Strathfield Internal Development Assessment Panel Meeting

Friday, 6 March 2020

TO: Strathfield Internal Development Assessment Panel Meeting - 6 March 2020
REPORT: IDAP – Report No. 1
SUBJECT: DA2019/183 - 3 MERLEY ROAD, STRATHFIELD - LOT 12 DP 19348
DA NO. 2019/183

Proposal: Demolition of existing buildings and construction of two (2) storey dwelling with basement level, swimming pool and associated front fence and landscaping

Figure 11: Ground floor plan

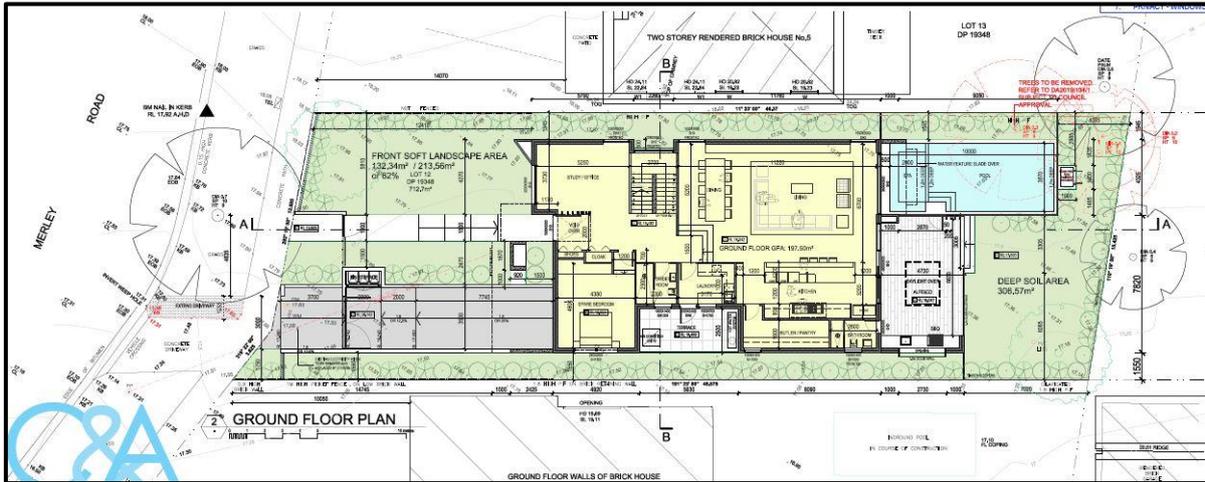
A Ground Floor Plan and Elevations of the proposed dwelling are shown in Figures 11 to 12.

Figure 3: proposed level 3 tenancy layout plan.

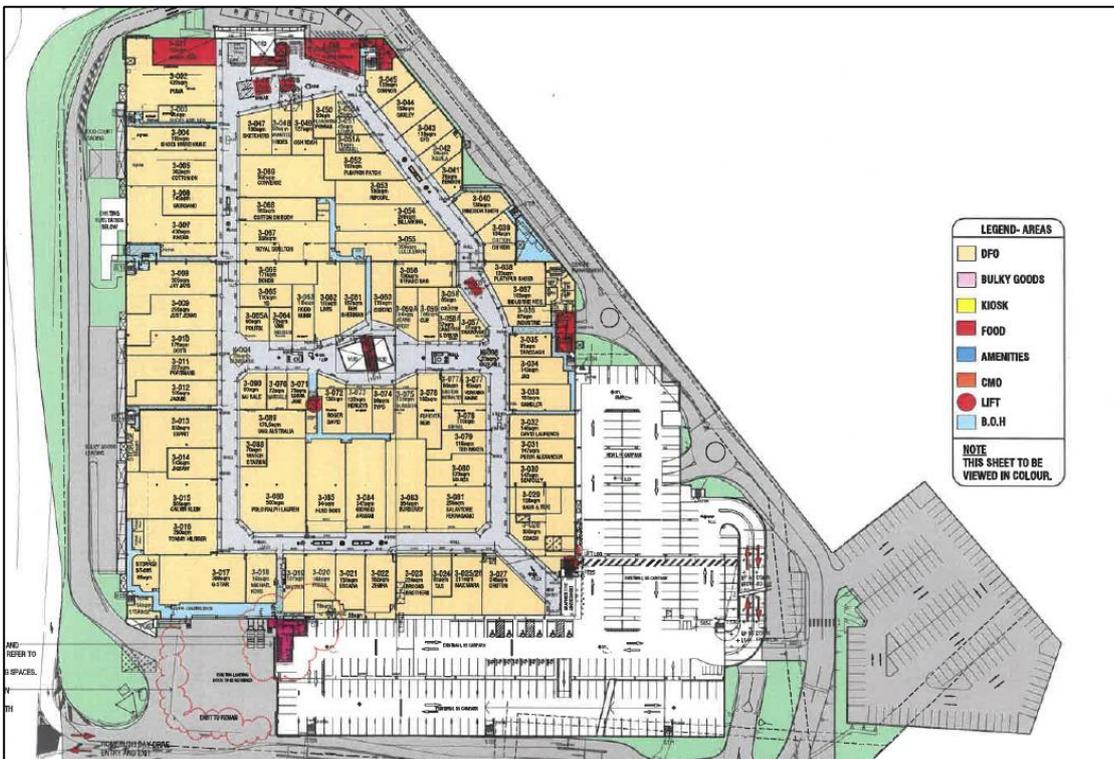
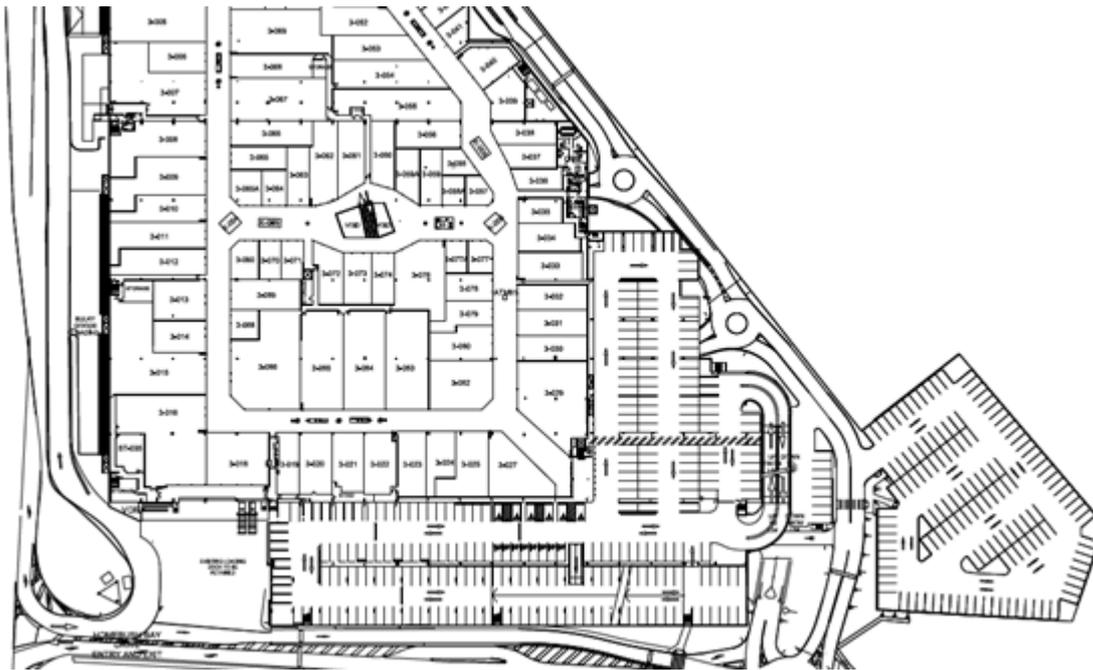
The proposal has sought minor amendments to the approved Level 3 floor plan of the building to reflect the current tenancy layout:

Specifically, the tenancy layouts have been modified to reflect the following (refer to Figure 2 and 3):

No physical works are proposed and no changes to the overall floor space of the site are proposed. The proposal is intended to update the tenancy layouts throughout Level 3 of the complex.

Figure 3: proposed level 3 tenancy layout plan.

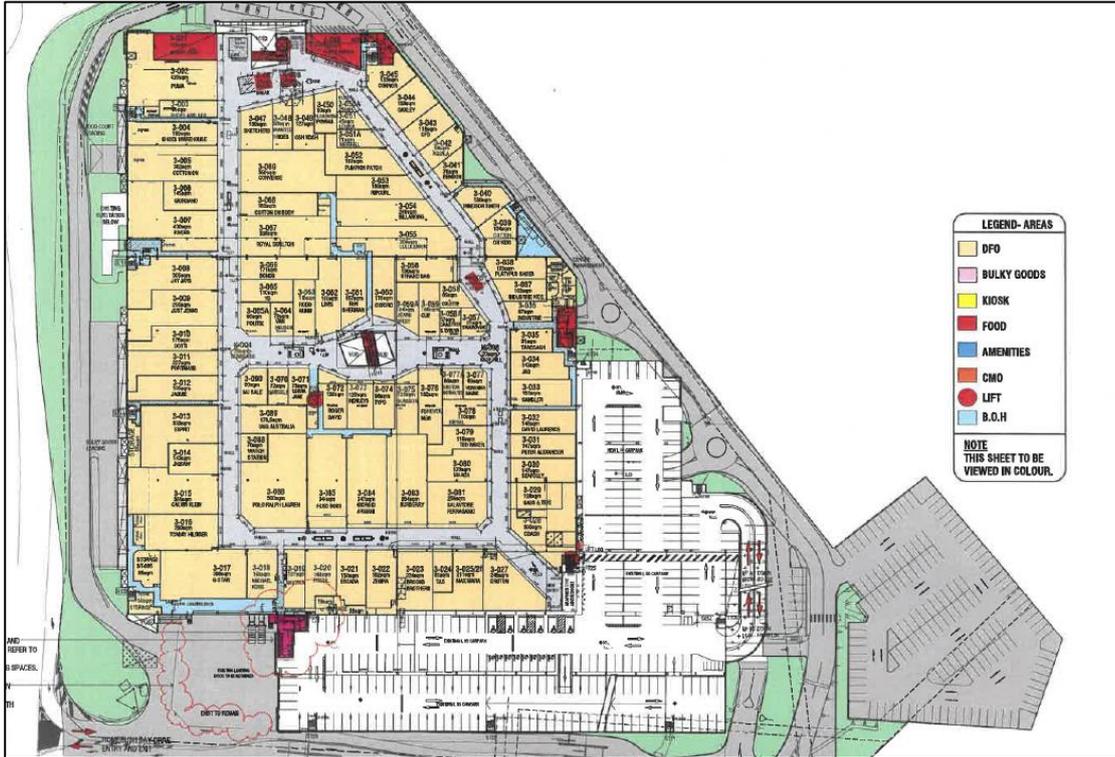
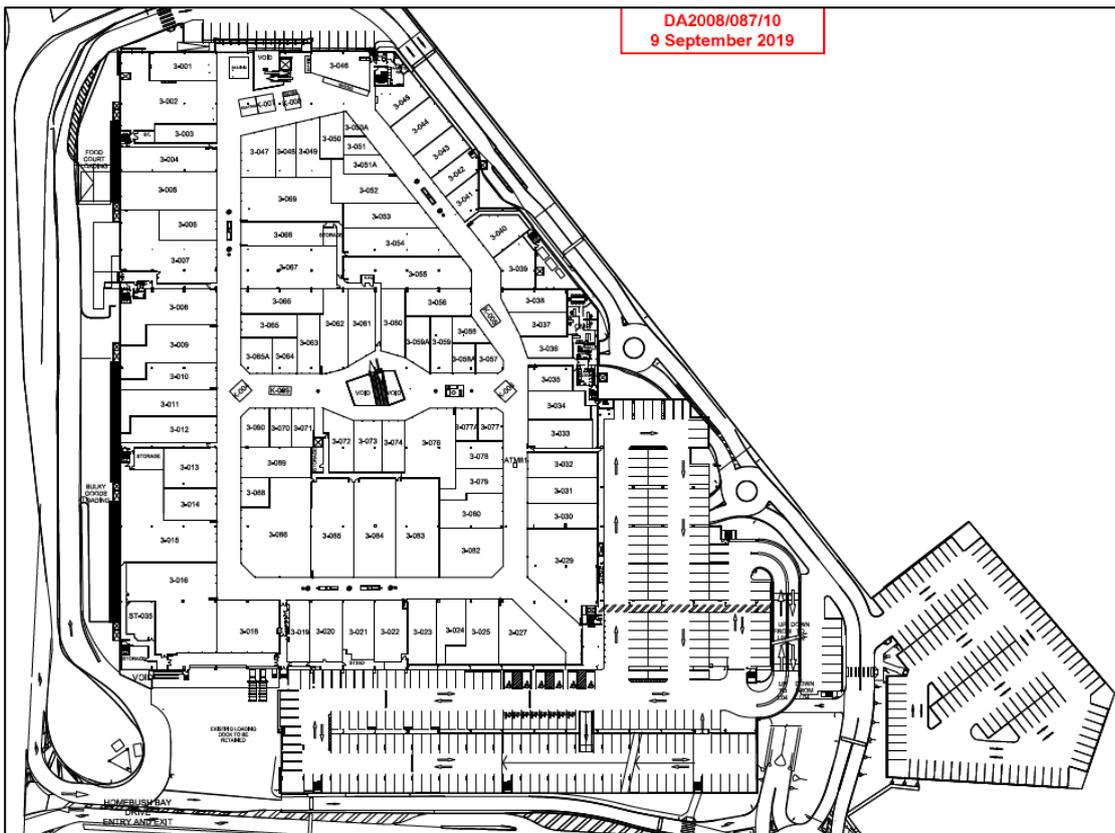
Specifically, the tenancy layouts have been modified to reflect the following (refer to Figure 2 and 3):

Figure 3: Proposed new ground floor plan demonstrating location of temporary storage area and at-grade loading bay.

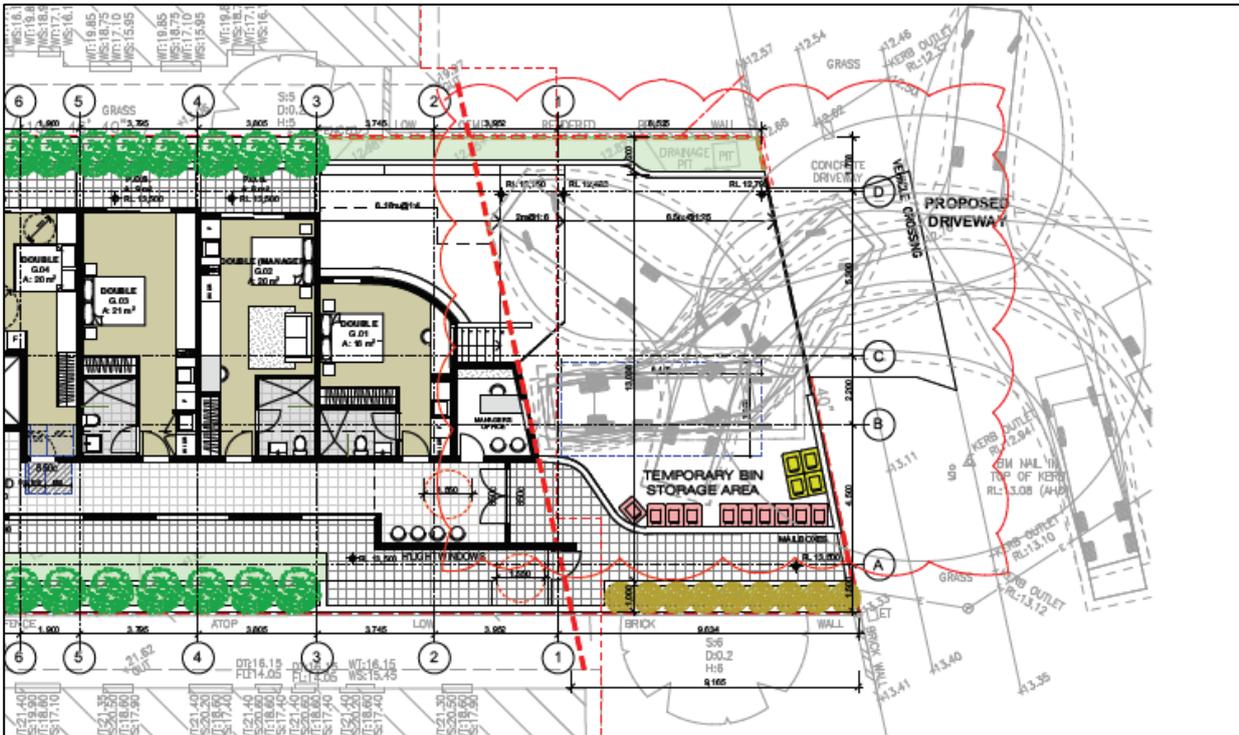
the development to accommodate for such requirements. The revised design now provides an at-grade collection bay in the front setback of the site with a temporary waste storage area immediately adjoining this area. A bin storage and a separate bulky storage area is now provided within basement level 2 of the building. Accordingly, bins will no longer be stored along the southern side boundary of the site as was previously required under the parent consent.

NOTE: Due to the design changes required to be made to the development, it is recommended that the development description of the subject modification application be modified. It is recommended that the development description reads as follows:
